New Berry Bucket Pin Upgrade

Part Number: 160697

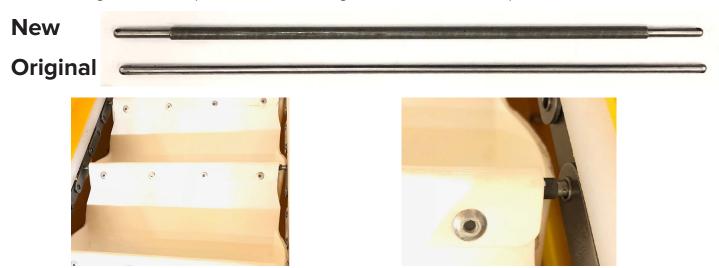
Oxbo now offers a new, improved bucket pin that is compatible with any 7440, 7420 or 9120 harvester. The new pin has the same diameter as the existing pins at either end, but is thicker in the middle to create a shoulder. This design delivers improved chain tracking and service life of the pin.

Note: the shoulder on the new pin is larger than the diameter of the hole in the chain and can not be inserted from the end. Therefore, the original pin is still valuable for quick, in-field repair during harvest.
